MONTICELLO NUCLEAR GENERATING PLANT
Docket No. 50-263 License No. DPR-22

License Amendment Request Dated August 16, 1978

REQUEST FOR AMENDMENT TO
OPERATING LICENSE NO. DPR-22

SUPPLEMENT 1 FOR MONTICELLO RELOAD 6
SIMMER MARGIN EVALUATION

Figure 1. Monticello EOC7 Turbine Trip Without Bypass, Trip Scram, 100.0% Power

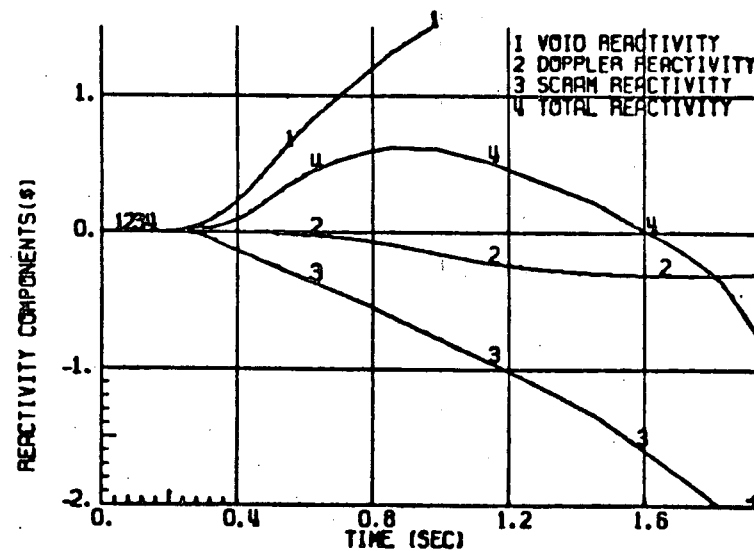
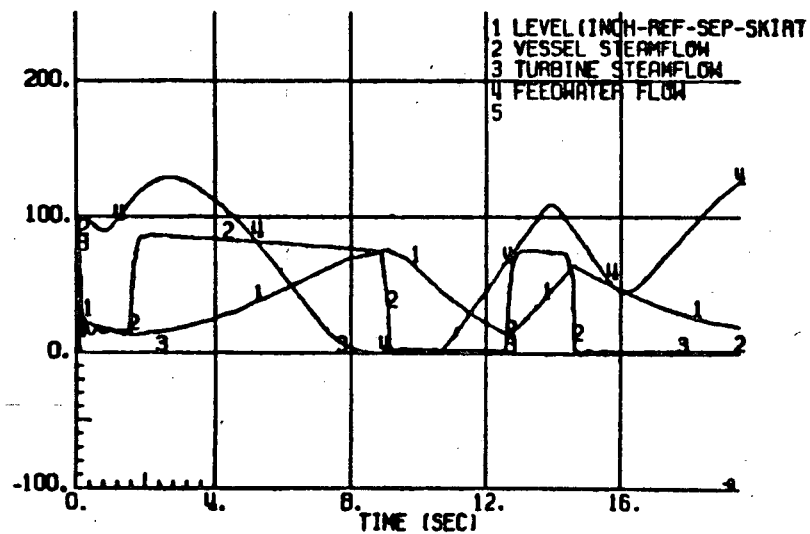
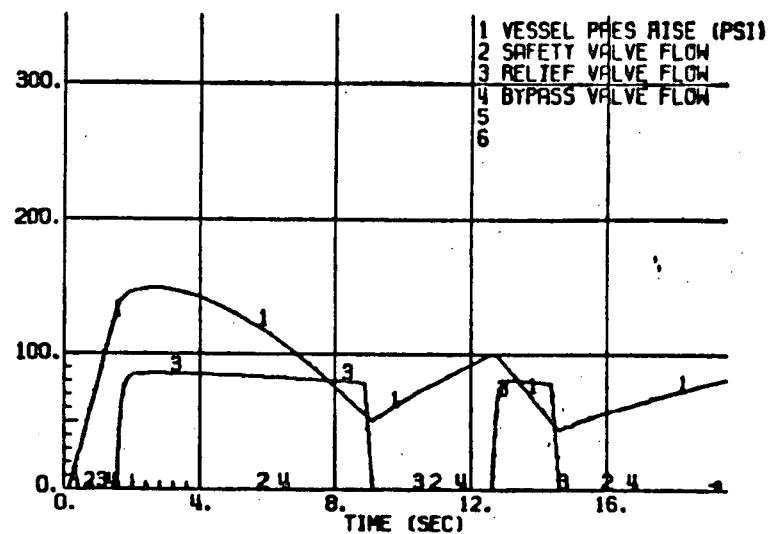
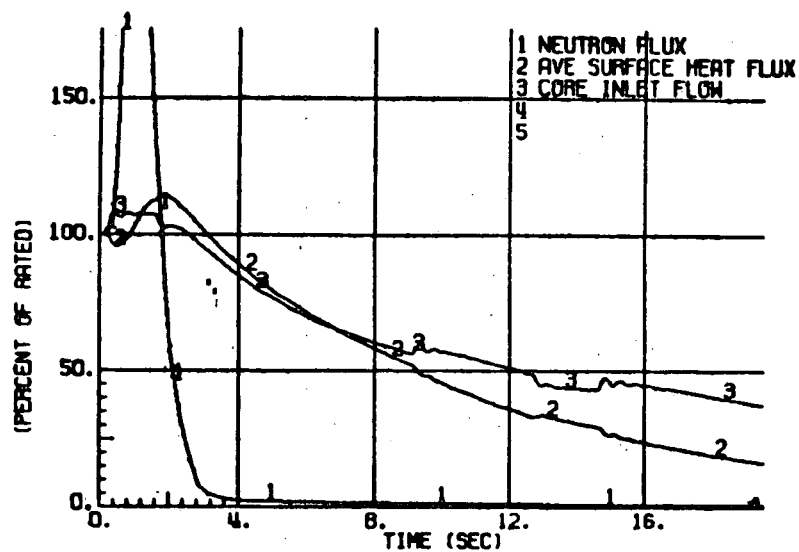
This transient produces the most severe reactor isolation. The primary characteristic of this transient is a pressure increase due to the obstruction of steam flow by the turbine stop valves. The pressure increase causes a significant void reduction, which yields a pronounced positive void reactivity effect. The net reactivity is sharply positive and causes a rapid increase in neutron flux until the net reactivity is forced negative by a scram initiated from position switches on the turbine stop valves and by a void increase after the safety/relief valves have automatically opened on high pressure. The results of these analyses are given in Table 1 and shown in Figure 1.

The change in critical power ratio caused by the change in setpoint is insignificant ($0.002 \Delta\text{CPR}$). However, this change was enough to affect the roundoff of the third significant figure, so that the ΔCPR for turbine trip without bypass with increased simmer margin is 0.26. Therefore, the MCPR Operating Limit with increased simmer margin is 1.33 for both 8x8 and 8x8R fuel.

Figure 2. Monticello EOC7 MSIV Closure, Flux Scram

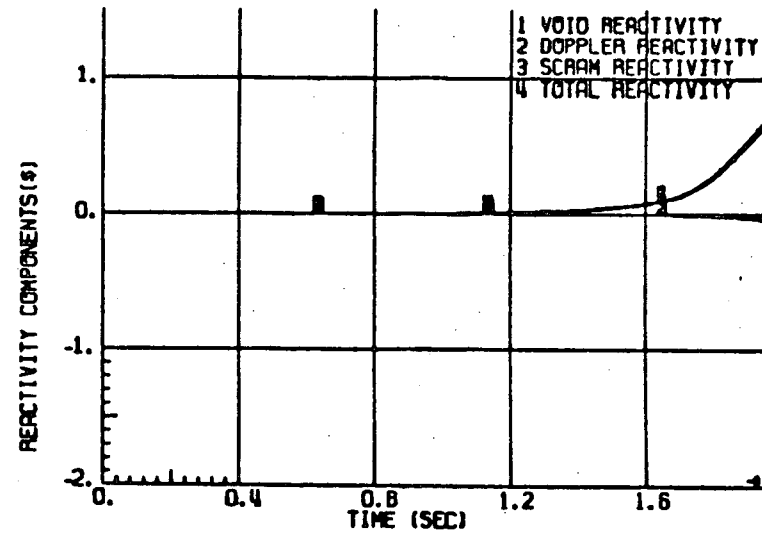
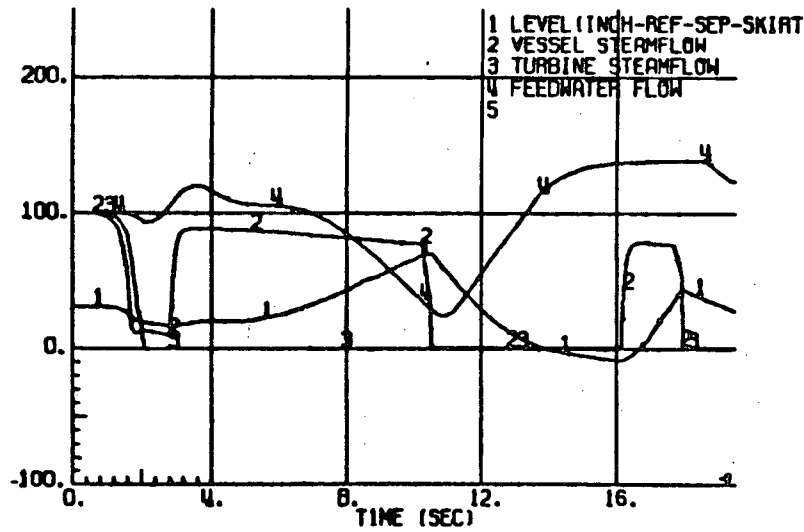
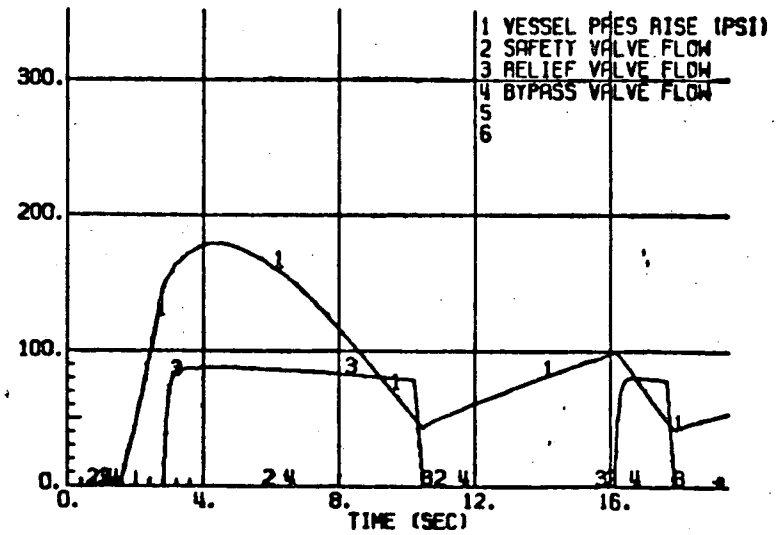
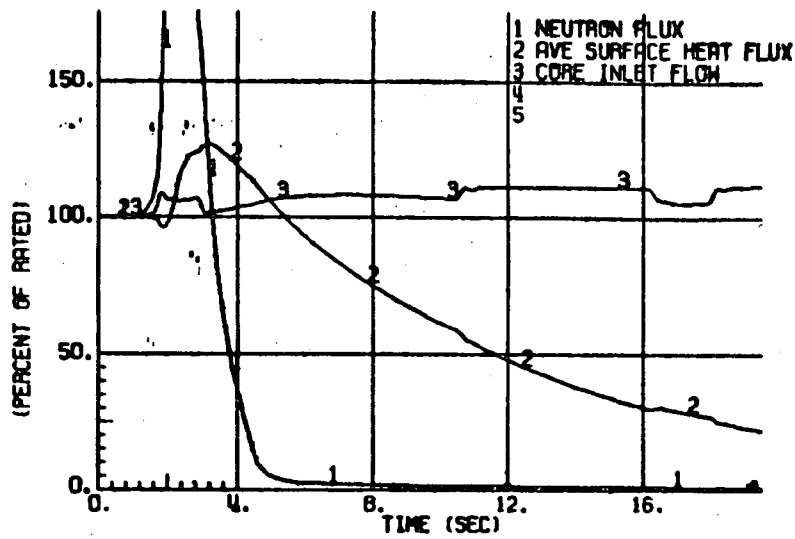
The event which satisfies this specification is the closure of all main steamline isolation valves with indirect (flux) scram. The initial conditions assumed are those specified in Section 6 of NEDO-24133. Figure 2 graphically illustrates the event. An abrupt pressure and power rise occurs as soon as the reactor is isolated. Neutron flux reaches scram level at about 1.7 seconds, initiating

reactor shutdown. The safety/relief valves open to limit the pressure rise to 1248 psig at the bottom of the vessel. This response provides a 127 psi margin to the vessel code limit of 1375 psig. Thus, requirement (a) is satisfied and adequate overpressure protection is provided by the pressure relief system.
